CHANGE ORDER

Project Name: **Haverhill Consentino Middle School** CO No. **11**

See attached list of 9 item(s) for a total of **\$22,166.91**

JD-95, A2.13, A2.23

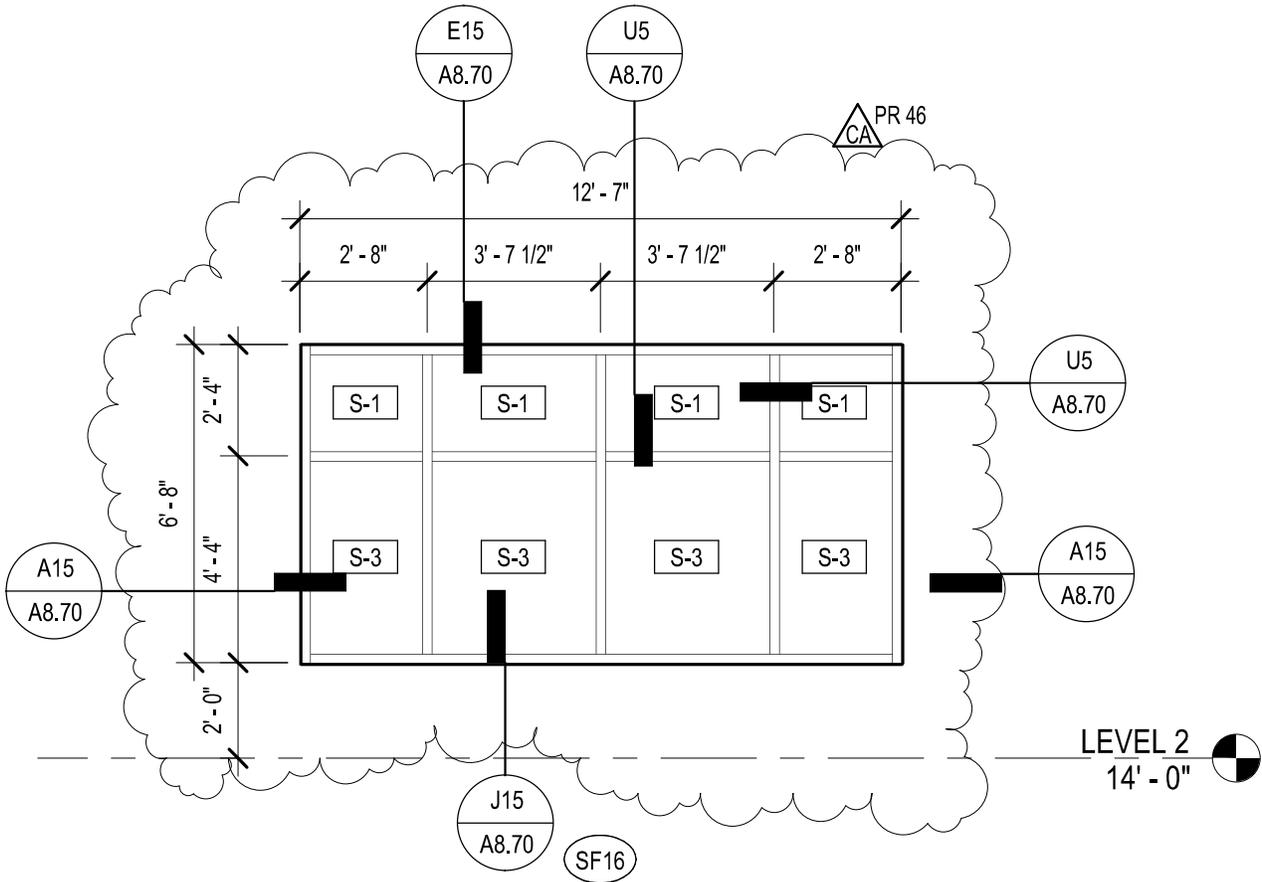
To coordinate with RFIs and coordination meetings with contractors, revise ceiling heights as shown on attached **A2.13** and **A2.23**, Level 1 & 2 Area C Reflected Ceiling Plans.

Sheet A8.03, Storefront Elevations, make the following revisions:

Revise SF 16 as shown on attached sketch **JD-95**.

Delete SF 12 at media center in its entirety. Storefront to be removed from E18/AQ1.54 and A15/A1.60.

A2.23

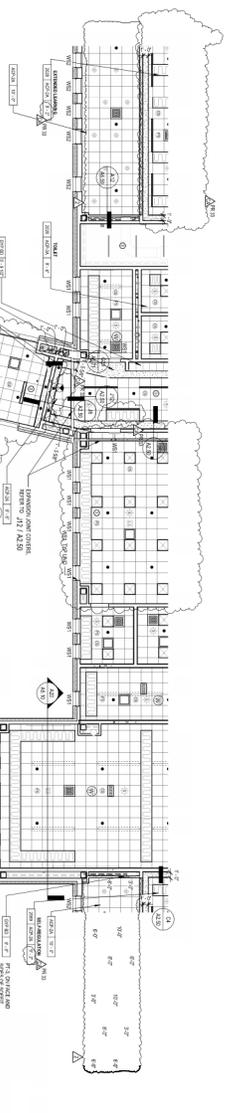
To coordinate with steel joist seat along grid C7.0, revise cafeteria clouds at Q12, Ceiling Plan – Cafeteria Clouds as shown on the attached sheet, **A2.23**.

SUBJECT: RFI #203: CMS-RFI #203-WGE RFI 40 VRFc Units-Branch Controllers

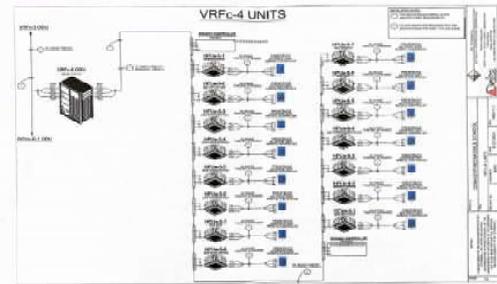
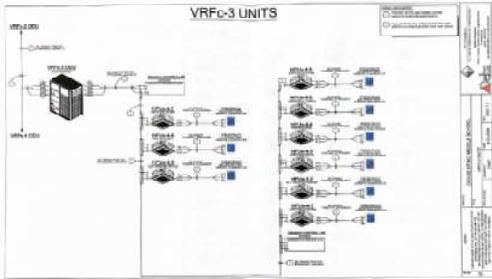
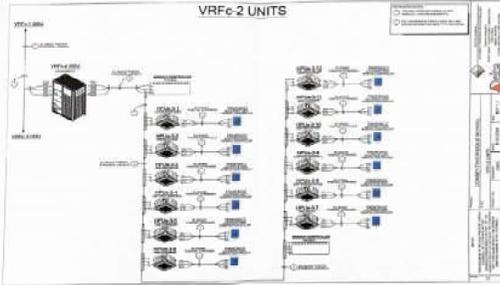
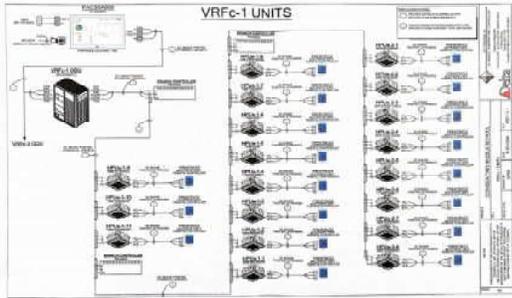
Having reviewed submittal for the VRFc units, it appears that there are more branch controllers than what is called for on drawing E3.05A.

Please confirm which panels and circuits are to be used for the added equipment?

1. *Connect additional branch controllers with existing circuits serving existing branch controllers serving associated systems. Provide thermal switches as disconnecting means for all additional branch controllers.*
2. *HVAC Contractor shall bear cost of all additional electrical work for substituted systems.*

JD-101

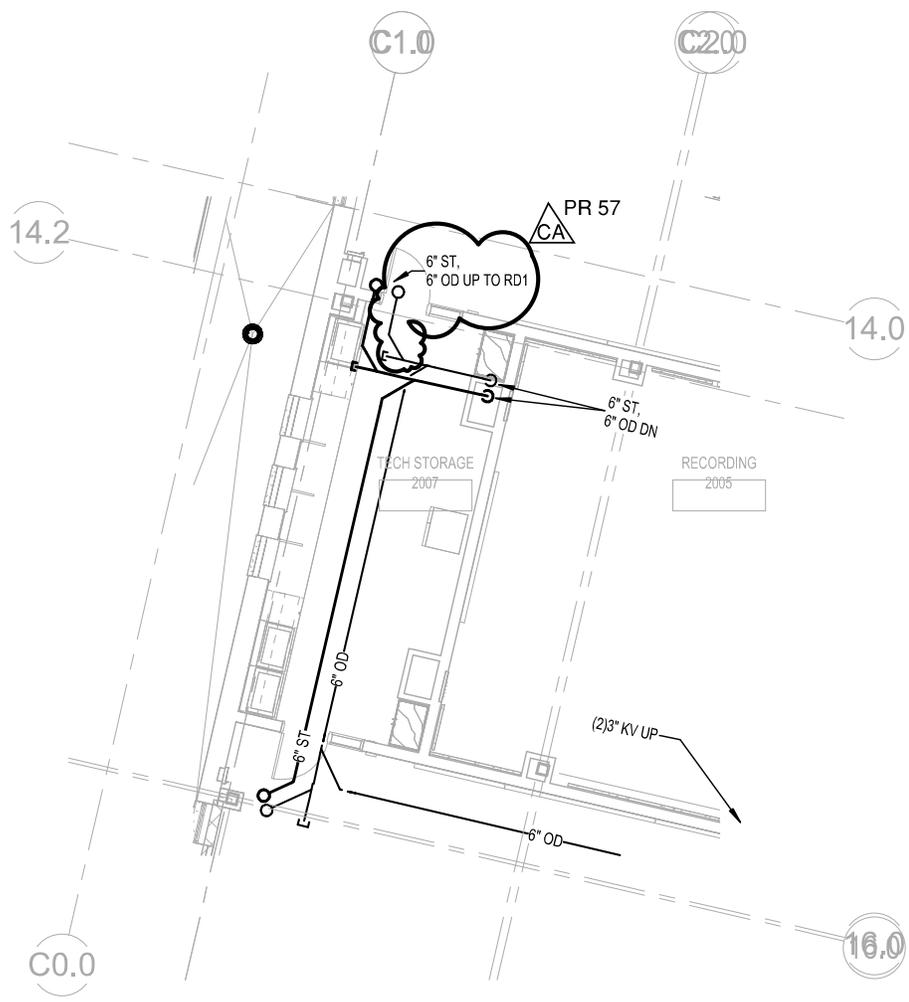
To coordinate with RFI 229 , at Sheet P2.13, revise plumbing at Tech Storage as shown on attached **JD-101**.

JD-106

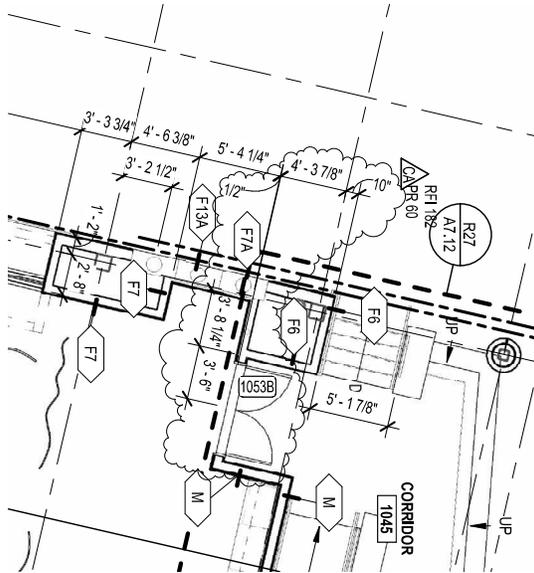
To coordinate with previously issued RFI 182 and ongoing duct work coordination, make the following revisions:

At Sheet A1.14, Level 1 – Area D, revise plan layout at Music Room 1053 entry as shown on attached **JD-106**.

At Sheet A2.14, Level 1 Reflected Ceiling Plan, Area D, add soffits as shown on attached sketch **JD-106**. Per 12 32 00 – 005R1, height of music casework anticipated to be 85 5/8". AV rack anticipated to be 72" tall. It would be acceptable to make alcove soffits 7'-3" above platform finish floor.

At Sheet A2.23, Level 2 Reflected Ceiling Plan, Area C/D, center acoustic panels at deck between relocated M partition / double door, and acoustical door jamb soffit.

JD-109

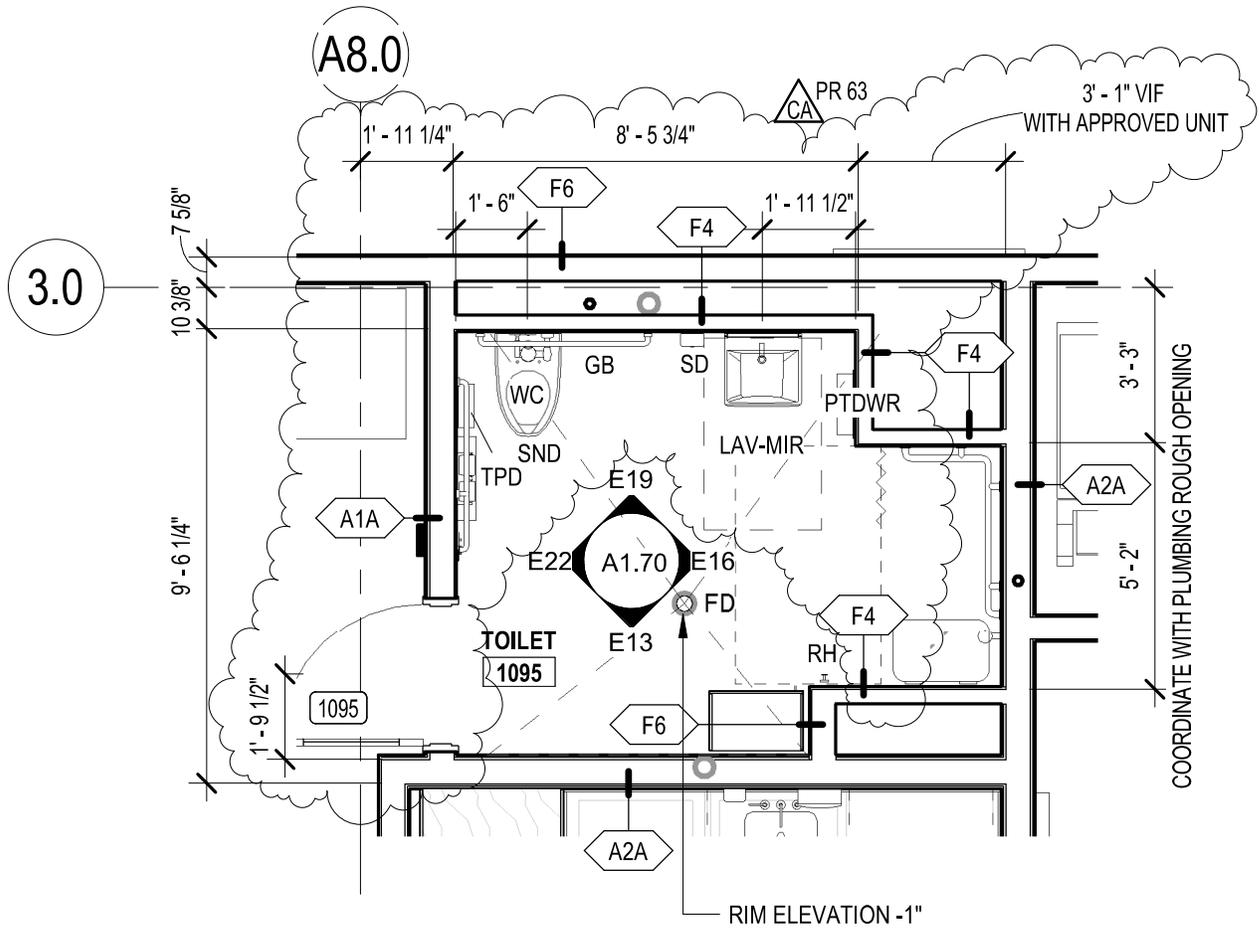
To coordinate with approved ADA shower unit, revise as follow:

Sheet A1.70, Enlarged Toilet Plans, at E27, Enlarged Plan – Toilet 1095, revise the location of partitions and plumbing fixtures as shown on the attached sketch **JD-109**. Contractor to coordinate tile revisions with previously approved shop drawings.
